Comparison of the sum of the ratios to regulatory concentrations limits at ALPS inlet/outlet [Revised Version]

December 21, 2022

TEPCO

1. Overview

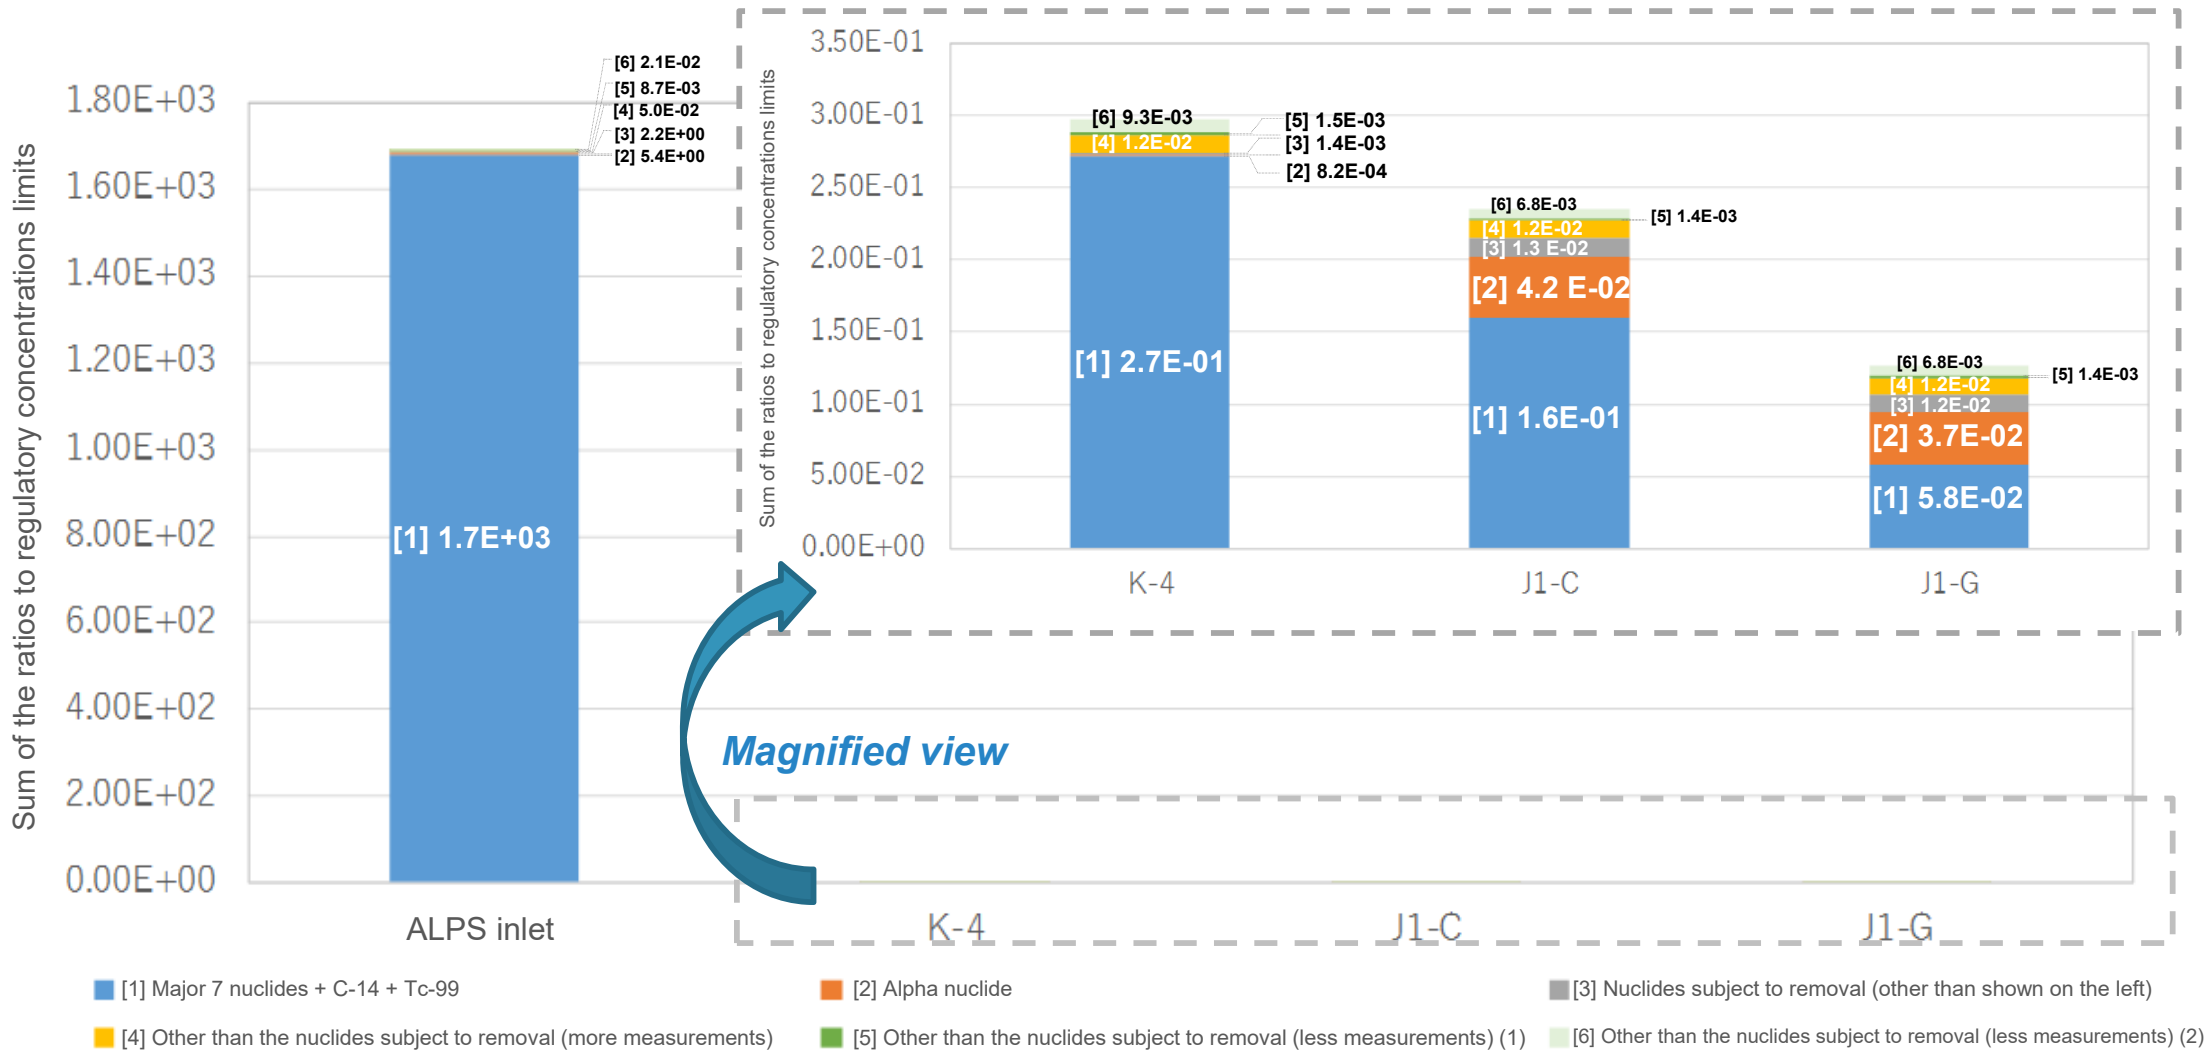
- For the 35 nuclides of the nuclides to be measured/assessed and monitored, the analytical results at the ALPS inlet (FY 2021) and ALPS outlet (K4, J1-C, J1-G) are reported based on the results of checking the sum of the ratios to regulatory concentrations limits in the classification in the table below. **Note that in the calculation of the regulatory concentration limit ratio of α -nuclides, the total- α value is divided by 4 Bq/L, which is the lowest regulatory concentration limit among the α -nuclides selected.**

*For J1-C and J1-G, the analysis and evaluation results for Cl-36, Se-79, ~~Ba-133~~, Fe-55, Nb-93 m, and Mo-93 are not available, and the results from the additional ALPS outlet are used.
